This supporting document is submitted on behalf of Berekdar Developments Limited in support of a section 73 application for the development of the residential site located at 37 Edward's Avenue in Ruislip.

The scope of the document is to provide details of the proposals to improve the previously approved scheme under Full Planning Application with the reference number 65680/APP/2011/36 and planning condition discharge with the reference number 65680/APP/2014/2485.

2.1 PROPOSAL COMPARISON - PLANS

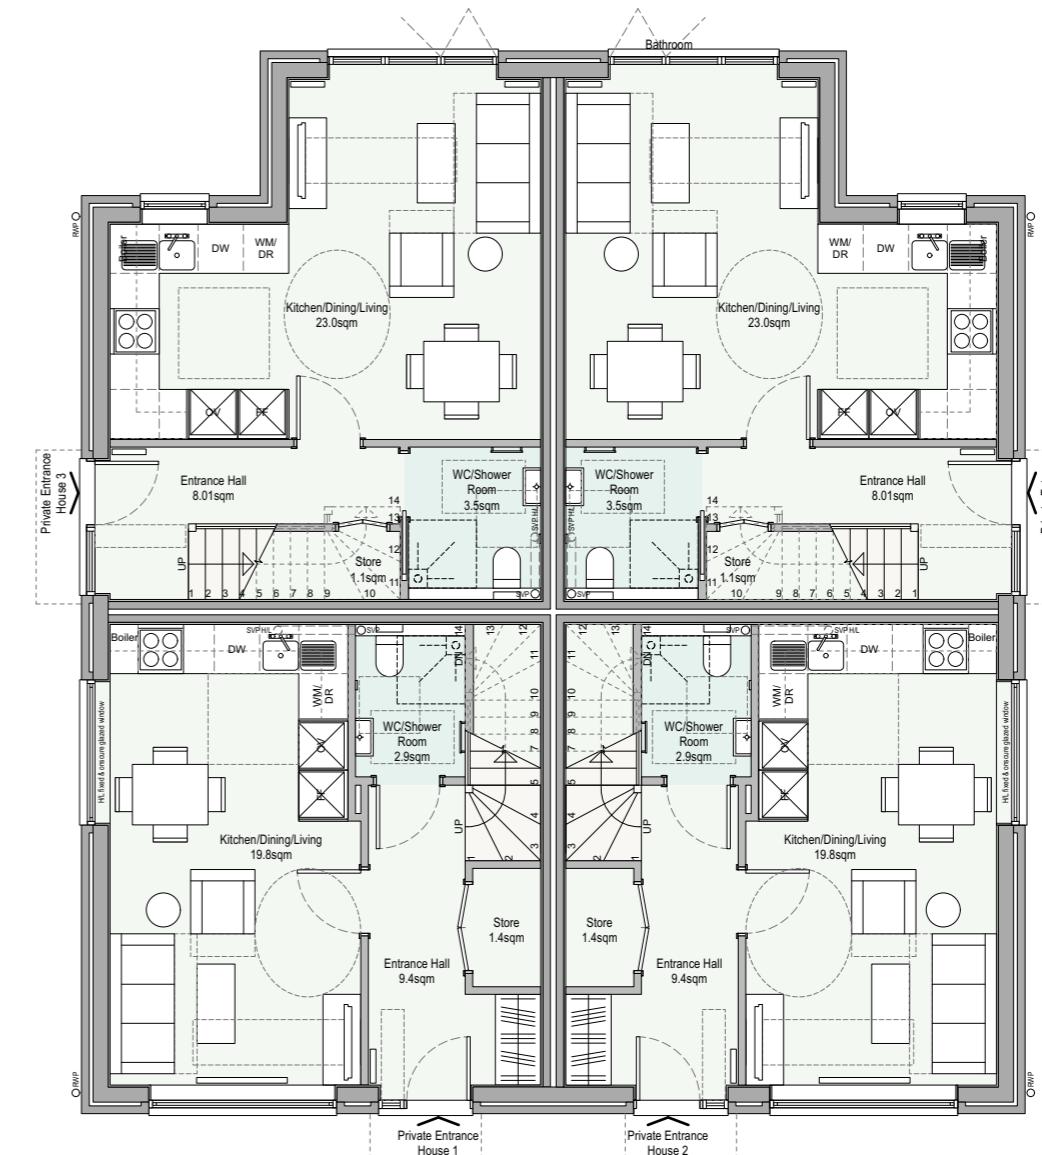
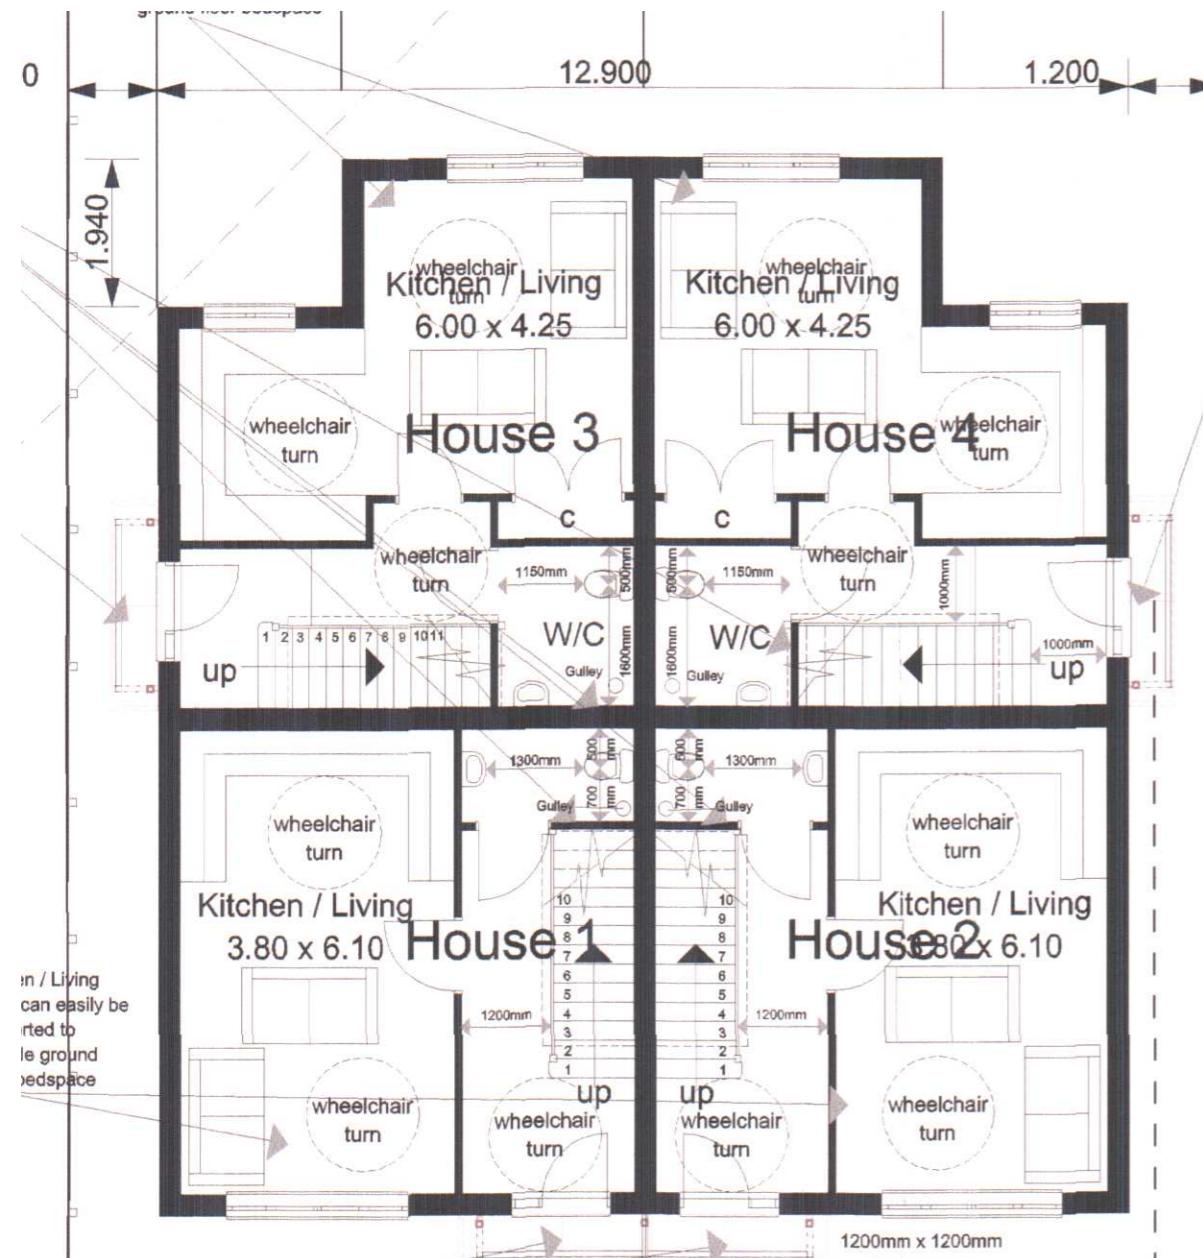
- Building and openings set out to metric brick sizes
- Entrance doors and glass side panels revised
- External building design modernised, whilst referencing it to 1940s/50s dwellings of similar nature found in the close vicinity of the site (see precedent image 1 for

- Level thresholds provided to access the building
- Pitched roof canopies replaced with flat roof canopies
- Rear facade bifold doors provided to living rooms
- Building shell thickness adjusted to conform to current Approved Document Part L1 thermal performance

requirements, resulting in reduced unit sizes, whilst still meeting nationally described space standards

- Internal layout arrangements adjusted to conform to current planning policy 'Accessible Hillingdon SPD 2017, to the London Plan 2021 and Approved Document Part M 4 (2) Accessible and Adaptable dwellings
- Internal layout arrangements adjusted to conform to

- Rainwater goods introduced
- Roof form corrected as it was drawn incorrectly on the approved plans.
- Roof pitch has been retained.

Proposed first floor plan (not to scale)

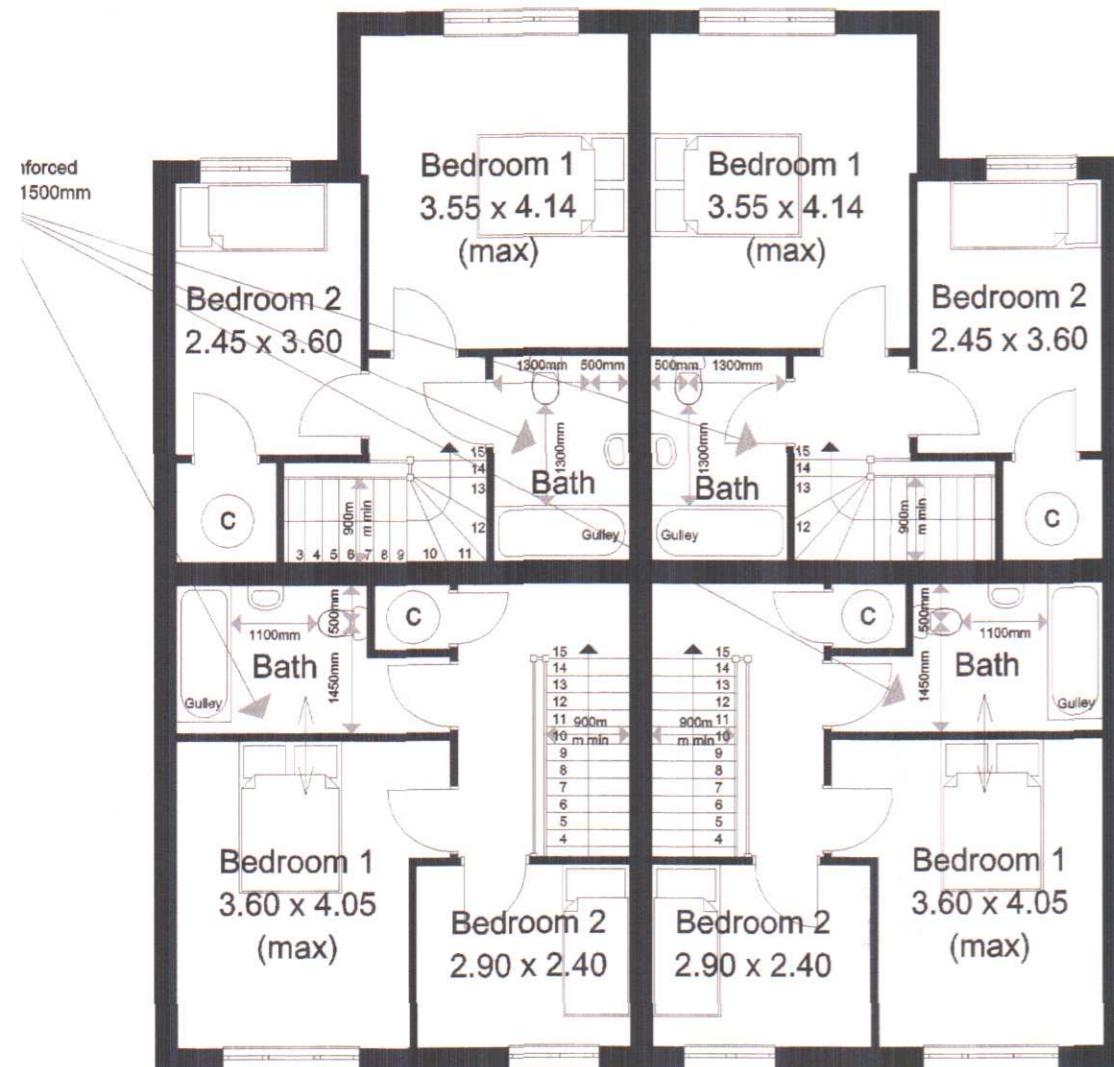
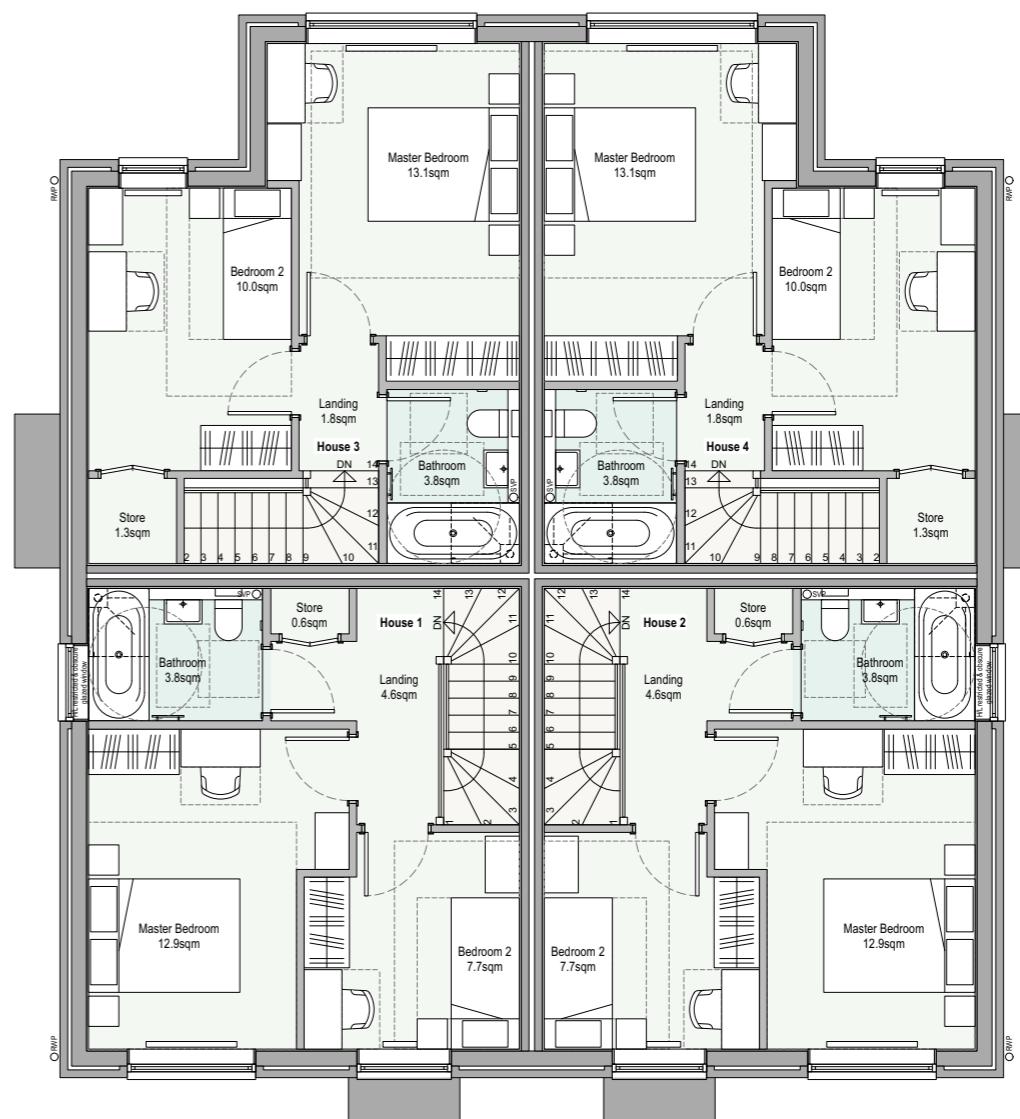
- Building and openings set out to metric brick sizes
- Entrance doors and glass side panels revised
- External building design modernised, whilst referencing it to 1940s/50s dwellings of similar nature found in the close vicinity of the site (see precedent image 1 for

- Level thresholds provided to access the building
- Pitched roof canopies replaced with flat roof canopies
- Rear facade bifold doors provided to living rooms
- Building shell thickness adjusted to conform to current Approved Document Part L1 thermal performance

requirements, resulting in reduced unit sizes, whilst still meeting nationally described space standards

- Internal layout arrangements adjusted to conform to current planning policy 'Accessible Hillingdon SPD 2017, to the London Plan 2021 and Approved Document Part M 4 (2) Accessible and Adaptable dwellings
- Internal layout arrangements adjusted to conform to

- Rainwater goods introduced
- Roof form corrected as it was drawn incorrectly on the approved plans.
- Roof pitch has been retained.

Proposed roof plan (not to scale)

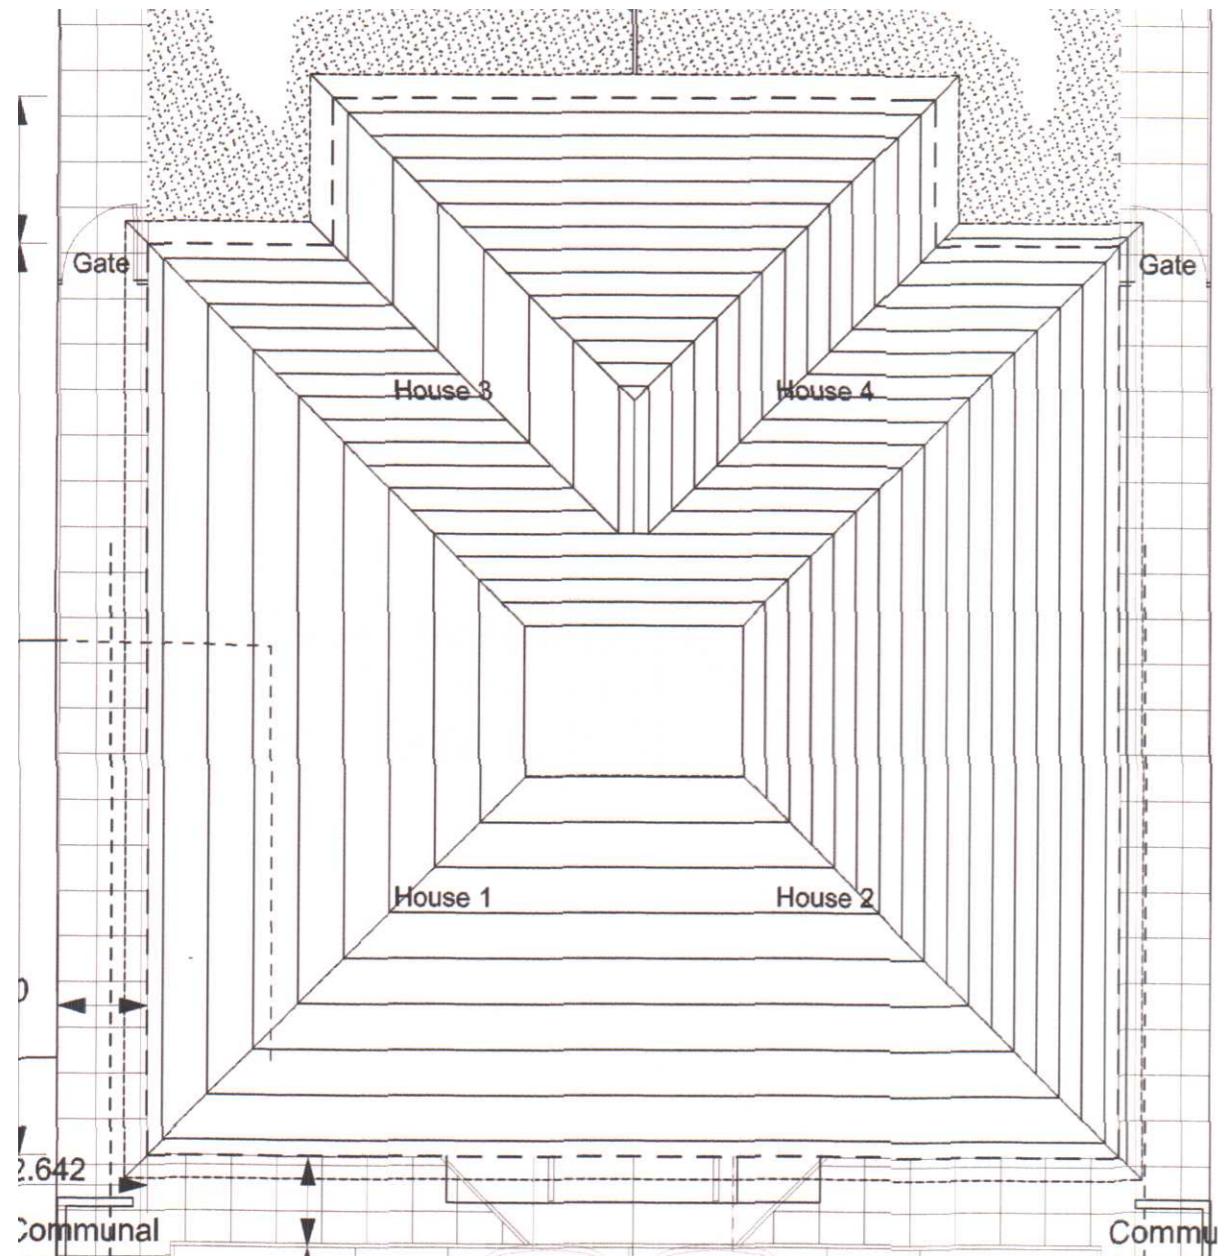
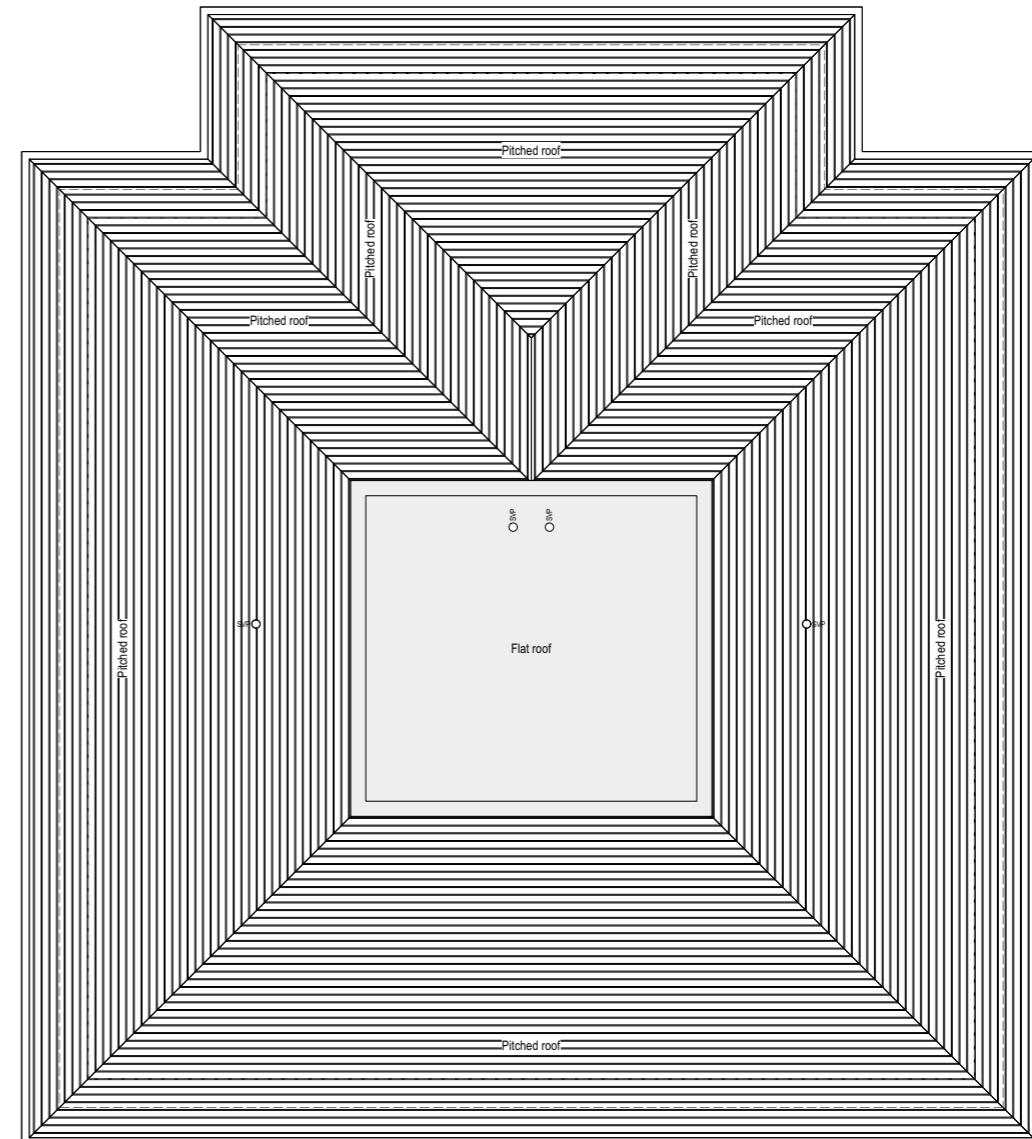
- Building and openings set out to metric brick sizes
- Entrance doors and glass side panels revised
- External building design modernised, whilst referencing it to 1940s/50s dwellings of similar nature found in the close vicinity of the site (see precedent image 1 for reference)

- Level thresholds provided to access the building
- Pitched roof canopies replaced with flat roof canopies
- Rear facade bifold doors provided to living rooms
- Building shell thickness adjusted to conform to current Approved Document Part L1 thermal performance

- Rainwater goods introduced
- Roof form corrected as it was drawn incorrectly on the approved plans.
- Roof pitch has been retained.

Proposed southeast elevation (not to scale)

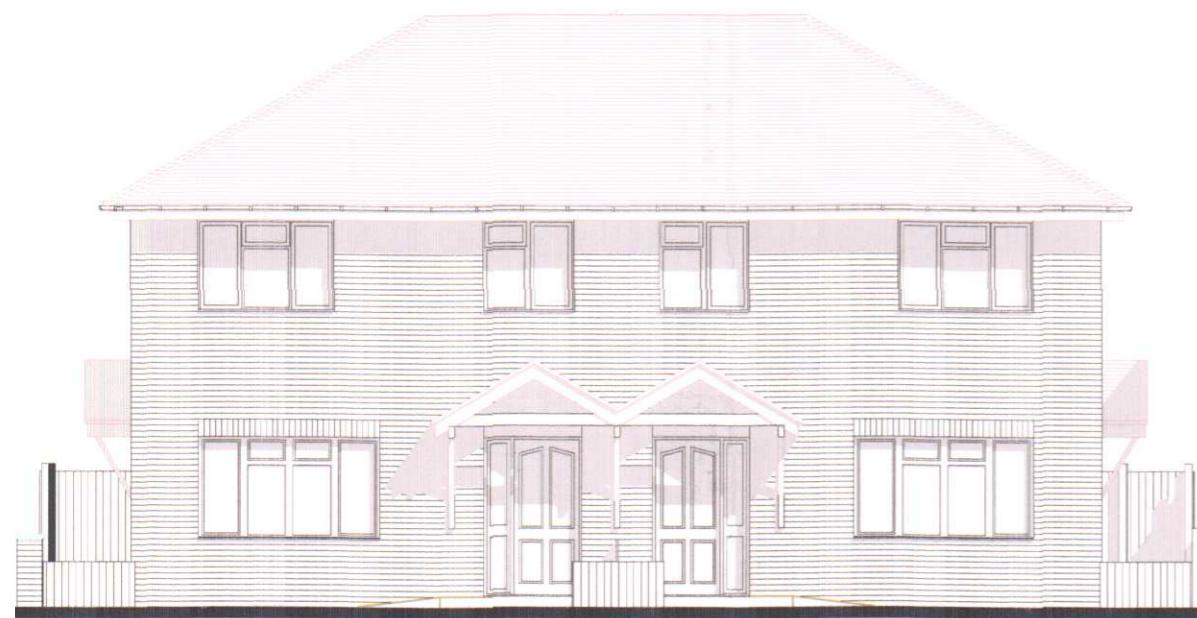
- Building and openings set out to metric brick sizes
- Entrance doors and glass side panels revised
- External building design modernised, whilst referencing it to 1940s/50s dwellings of similar nature found in the close vicinity of the site (see precedent image 1 for

- Brick detailing such as soldier courses and window cills in brick proposed
- Level thresholds provided to access the building
- Pitched roof canopies replaced with flat roof canopies
- Rear facade bifold doors provided to living rooms

- Window design amended, providing energy-efficient aluminium framed glazing in dark grey, with muntins to imitate heritage window
- Rendered plinth introduced
- Dark red/brown concrete roof tiling proposed

- High-level obscure glazed, restricted or fixed shut windows to site elevation proposed
- Roof form corrected as it was drawn incorrectly on the approved plans.
- Roof pitch has been retained.

Approved southwest elevation under application 65680/APP/2011/36 (not to scale)

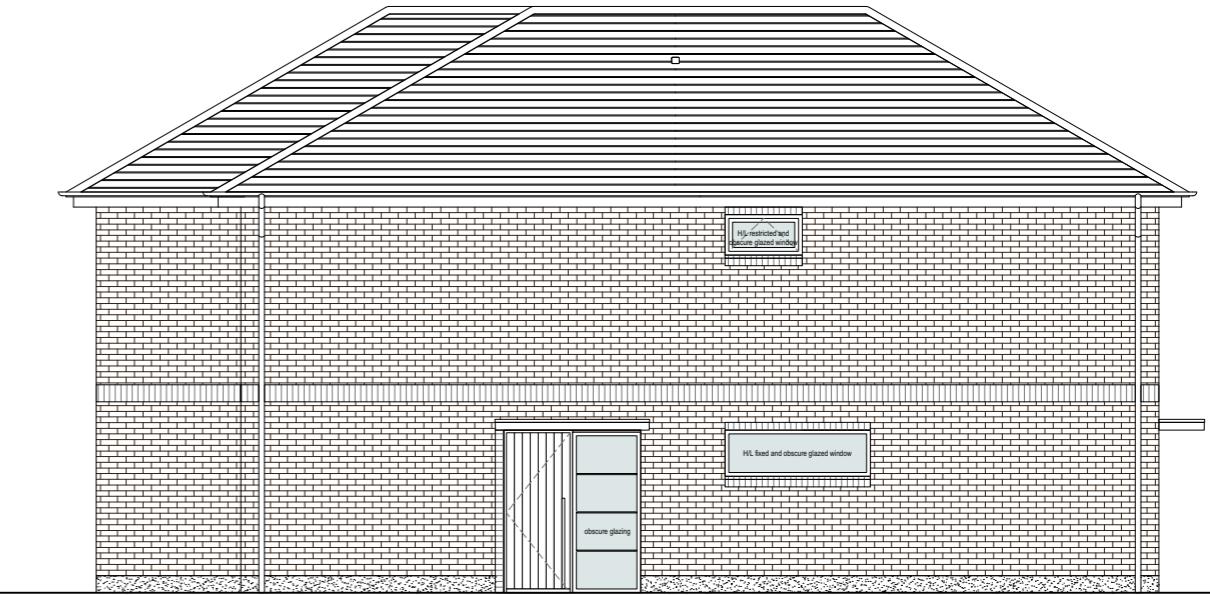
- Building and openings set out to metric brick sizes
- Entrance doors and glass side panels revised
- External building design modernised, whilst referencing it to 1940s/50s dwellings of similar nature found in the close vicinity of the site (see precedent image 1 for reference)

- Brick detailing such as soldier courses and window cills in brick proposed
- Level thresholds provided to access the building
- Pitched roof canopies replaced with flat roof canopies
- Rear facade bifold doors provided to living rooms

- Rainwater goods introduced
- Window design amended, providing energy-efficient aluminium framed glazing in dark grey, with muntins to imitate heritage window
- Rendered plinth introduced
- Dark red/brown concrete roof tiling proposed
- High-level obscure glazed, restricted or fixed shut windows to site elevation proposed
- Roof form corrected as it was drawn incorrectly on the approved plans.
- Roof pitch has been retained.
